UNITED STATES PATENT AND TRADEMARK OFFICE

| APPLICATION NO. | FILING DATE | FIRST NAMED INVENTOR | ATTORNEY DOCKET NO. | CONFIRMATION NO. |
|--|-------------|----------------------|---------------------|------------------|
| 10/658,338 | 09/10/2003 | Michael W. Bosse | 23122.01 | 1867 |

| Office Action Summary | Application No. | Applicant(s) | |

DETAILED ACTION

Figure 1 of D272,712 to Allen. Lead lines, reference numbers, and directions added by the examiner.

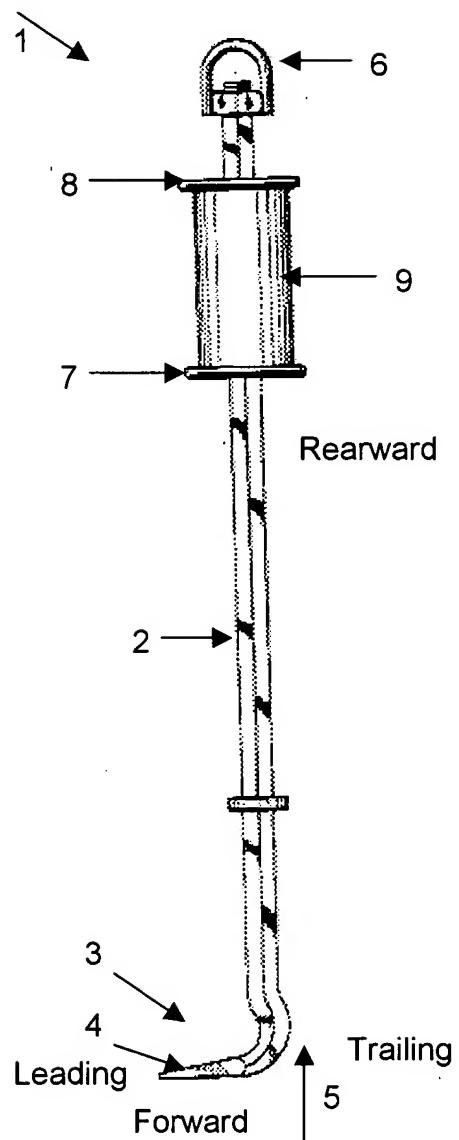
Regarding claim 1, Allen teaches a lock removal tool (1), comprising: an elongated bar (2) having a first end and a second end; a lock cutting tool (3) disposed on the first end of said bar (2), the lock cutting tool (3) being a generally rectangular, flat plate having leading (4) and trailing edges (5) and top and bottom surfaces, said bar (2) being joined to the lock cutting tool (3) generally between the leading (4) and trailing (5) edges, said bar (2) being angled away the top surface and extending rearward from the lock cutting tool (3); a tool piece (6) extending from the second end of said bar (2) axially aligned with said bar (2); a first impact collar (7) disposed on said bar (2) near the first end; a second impact collar (8) disposed on said bar near the second end; and a weight (9) slidably disposed on said bar (2) between the first (7) and second (8) impact collars. Note: impact collars (7, 8) are defined as such because they are circular members that impact the tool piece (6) and the lower collar.

Regarding claim 6, Allen teaches the leading edge (4) of said lock cutting tool (3) is bifurcated to form a cutting slot (10), the cutting slot (10) being a generally "V" shaped slot having inner edges.

Regarding claim 8, Allen teaches the leading edge (4) of said lock cutting tool (3) is bifurcated to form a cutting slot (10) being a generally "V" shaped slot having inner edges, the top surface of said cutting tool being tapered along the inner edges (11) of said cutting slot (10).

19. Applicant's arguments filed April 29, 2005 have been fully considered but they are not persuasive.
20. Regarding applicant's argument the Allen reference does not disclose a trailing edge, applicant is reminded the broadest reasonable interpretation of the term "trailing" can be used in rejecting the claim. Although applicant appears to be stating the term "trailing" is limited to mean "tapering," the examiner is interpreting the term to mean "following." Thus the edge (defined as a line or point at a beginning or an end) identified in the Allen reference as trailing indeed follows the leading edge.

22. Applicant argues the bar is not angled away from the top surface of the tool, but instead is perpendicular to it in the Allen reference. Applicant is reminded that a 90-degree angle is still an angle, and thus the bar is angled away from the tool. In addition, it should be noted that the top surface of the tool slopes upward, and as such the angle between the top surface and bar is actually greater than 90 degrees.

23. Regarding applicant's argument the bar does not extend rearward from the lock cutting tool in the Allen reference, applicant is directed toward FIG 1 of the *Figures* section. Directions have been added to this figure for further illustration. The figure clearly shows that the bar extends rearward from the tool.

Figure 1 (enlarged) of D272,712 to Allen. Lead lines and reference numbers added by the examiner.

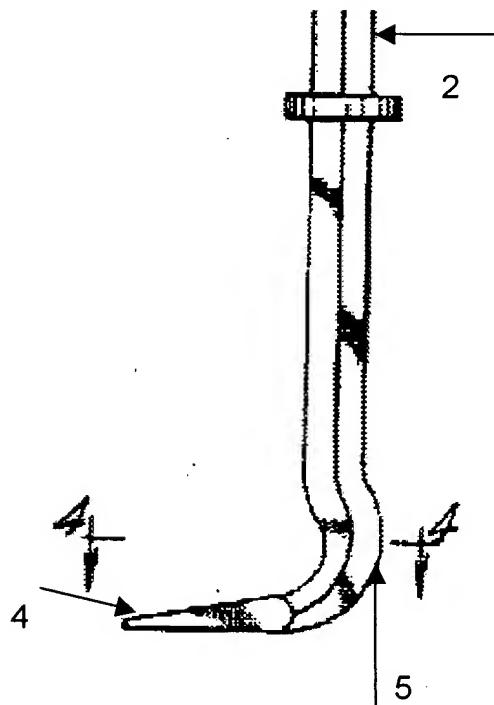
21. Regarding applicant's argument the bar is not joined between the leading and trailing edges in the Allen reference, the examiner disagrees. As shown in the *Figures* section of this action, the bar is clearly joined between the two edges. A further magnification of the figure has been included in order to aid understanding.
